03 - 2010  
HP2050/ HP2050H  
3/4" 2-SPEED HAMMER DRILL

**SERVICE CHANGES**

**2. Changes on Gear Com. and O Ring**

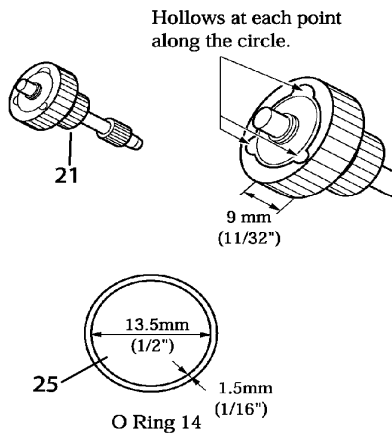
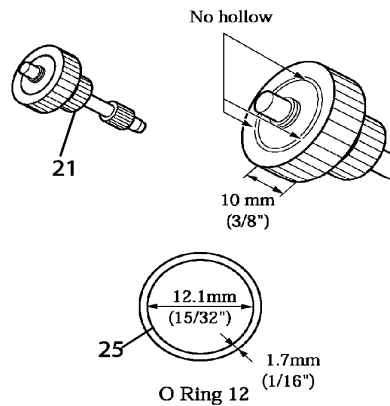
Item No.	Description	Type 1	Type 2
21	Gear Com.	153363-4 (N/L/A)	153622-6
25	O Ring	213162-7	213122-9
-	Grease N No.1 # 042017-7A	(use 38.5g)	(use 30.0g)

Above parts are completely interchangeable as a set.

**Type 1**

**Type 2**

**3. Addition of Adhesive and Modification of Gear Housing Cover Com.**

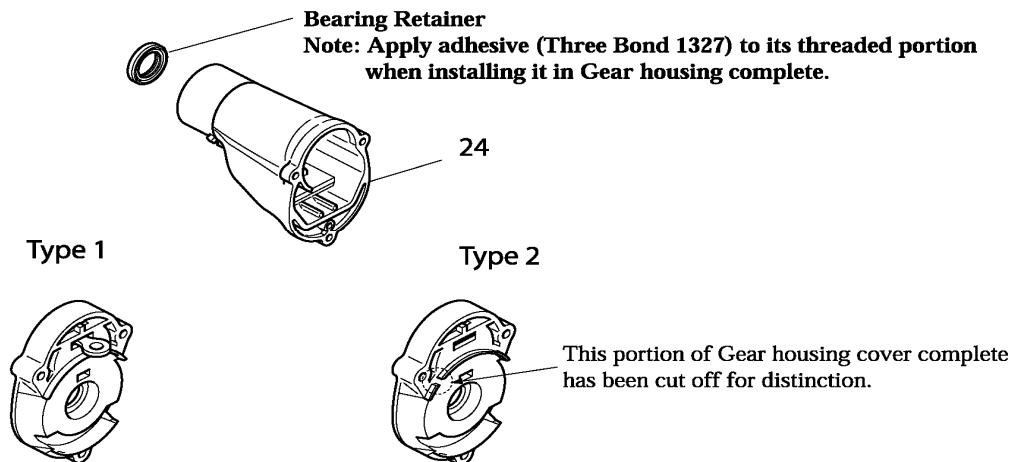
Item No.	Description	Type 1	Type 2
24	Gear Hsg Cover	153364-2 (N/L/A)	153620-0
